**CULTURAL RESOURCES OFFICE  
 PRESERVATION BOARD  
 REGULAR MEETING  
 MONDAY – SEPTEMBER 28, 2015 — 4:00 P.M.  
 1520 MARKET ST. #2000  
 ST. LOUIS, MO. 63103  
[www.stlouis-mo.gov/cultural-resources](http://www.stlouis-mo.gov/cultural-resources)**

DATE: September 28, 2015  
ADDRESS: 4205 Maryland and 345 Whittier Street  
ITEM: Preliminary Review: Demolish house at 4205 Maryland Avenue and commercial building at 345 Whittier Street for construction of MSD's Gaslight Square Sewer Improvement Project.  
JURISDICTION: Central West End Local Historic District — Ward 18  
STAFF: Betsy Bradley, Cultural Resources Office

DATE: September 28, 2015  
ADDRESS: 4066 Russell Boulevard  
ITEM: Preliminary Review: Construct a one-story commercial building on the site of an abandoned service station proposed for rehabilitation.  
JURISDICTION: Shaw Certified Local Historic District — Ward 8  
STAFF: Jan Cameron, Cultural Resources Office

DATE: September 28, 2015  
ADDRESS: 2018 Geyer Avenue  
ITEM: Preliminary Review to construct a two-story, four unit townhouse.  
JURISDICTION: McKinley Heights Historic District — Ward 7  
STAFF: Bob Bettis, Cultural Resources Office

RENDERING OF PROPOSED BUILDING FROM RUSSELL LOOKING SOUTHEAST

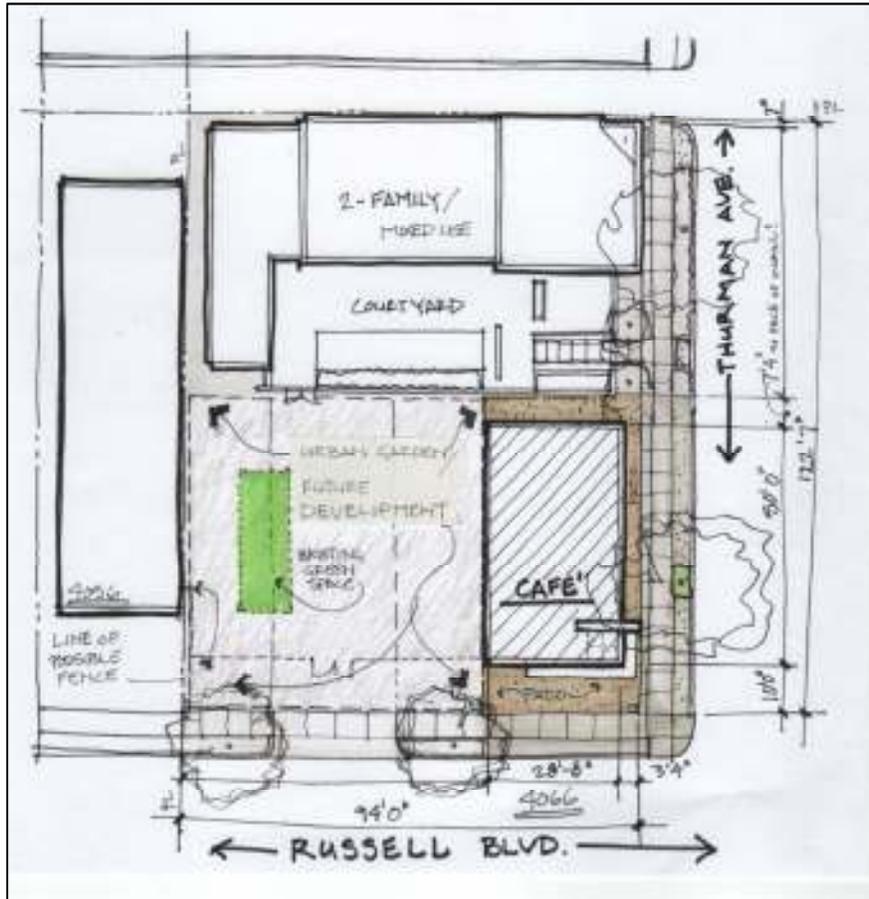
**Does not comply. The new building will be only one story. However, the existing building at the rear of the property is primarily a one-story garage with only a partial second story; and one-story buildings are extant to the east and directly opposite the site. The building has been designed to emphasize the corner with a vertical element that will add to its mass.**

**Generally complies. Along Russell, the building will align with the setbacks of the historic corner commercial buildings to the west. Along Thurman, the building will be set slightly back from the building line to accommodate a single row of outdoor tables; it will still succeed in filling what is now an empty corner.**

**Partly complies. The building is intended to replicate the exterior treatment proposed for the converted service station at the rear and to continue its Mid-century Modern vocabulary. The majority of the building will be faced in smooth-finished stucco, a material which was used historically on front facades in the district, although the majority of buildings in the immediate vicinity of the site have brick fronts. Many of these, however, have been painted in light colors and now present a uniform appearance that is similar to the proposed wall treatment. The vertical element will be clad in cementitious panels in a limestone color.**

**Partly complies. While the proposed details are contemporary in character, they reference materials and some details present in the district's historic buildings, such as a recessed corner entry and storefront.**

That the Preservation Board grant preliminary approval to the project with the stipulation that final drawings and exterior material finishes are reviewed and approved by the Cultural Resources Office.

SITE PLAN

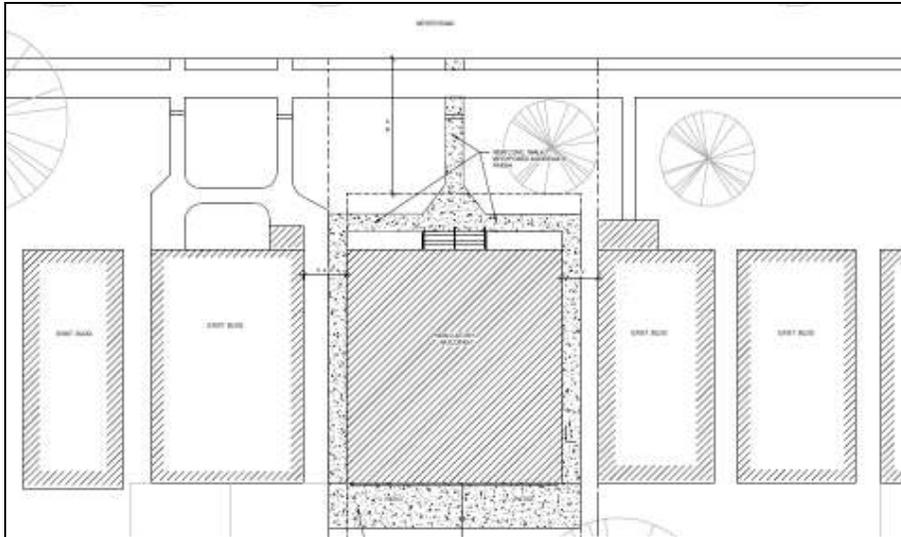
**Complies. The building will front on Geyer Avenue.**

**Complies. The new building will adhere to the building line on Geyer.**

NORTH ELEVATION

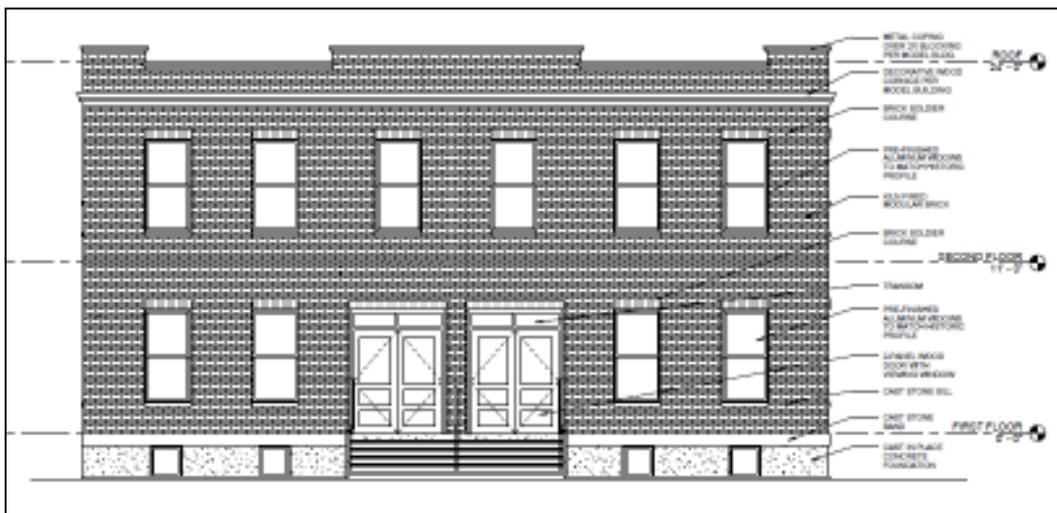
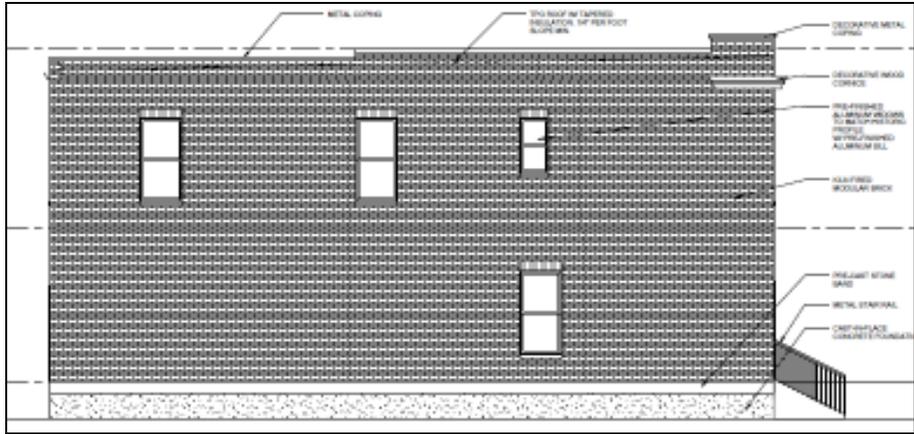
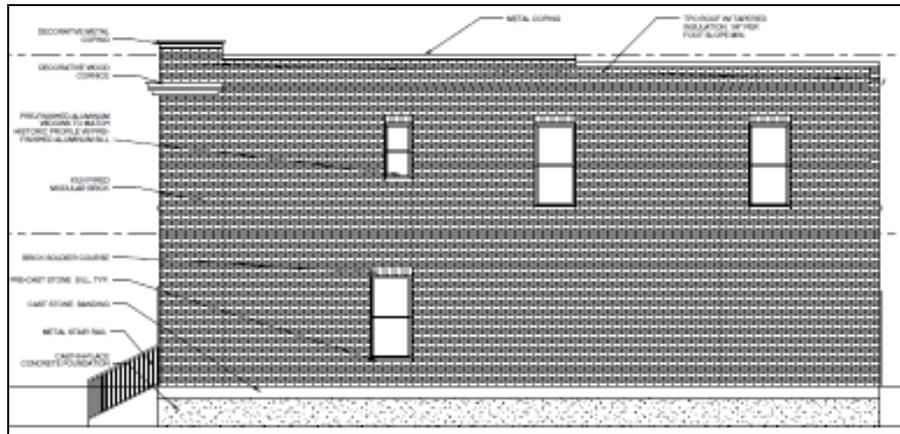
**Complies. The mass of the building shares visual characteristics with existing historic buildings on the street.**

**Complies. The building will be two stories in height and floor levels will be the same as the adjacent buildings.**

**Complies. Proportions of details on the Public Façade will follow those of the Model Examples.**

**Complies. The ratio of solid to void at the Public Façade follows that of its Model Example.**

**Appears to comply. No material samples have yet been submitted, but the applicant intends to use brick on three sides.**

That the Preservation Board grants preliminary approval with the condition that the design be developed as proposed and that the Cultural Resources Office review and approve final plans and materials.

3971 FLORA PLACE

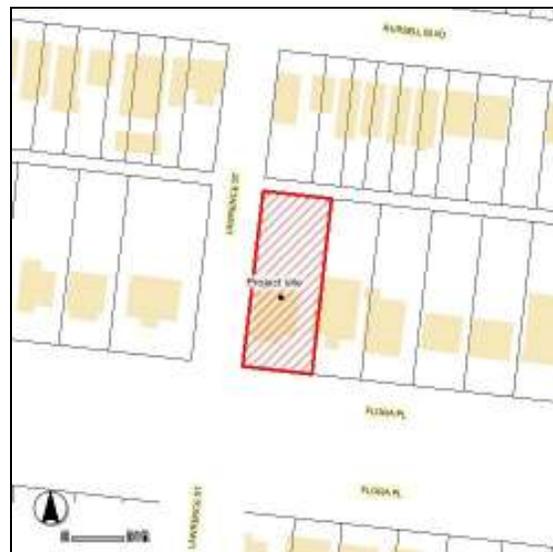
**Does not comply. The proposed retaining wall would be constructed with concrete units which is not an approved material under the historic district standards. The wall would not be completely vertical, as an historic retaining wall would have been.**

**RECOMMENDATION:**  
That the Preservation Board uphold the Director's denial, as the retaining wall does not comply with the Shaw Historic District Standards.
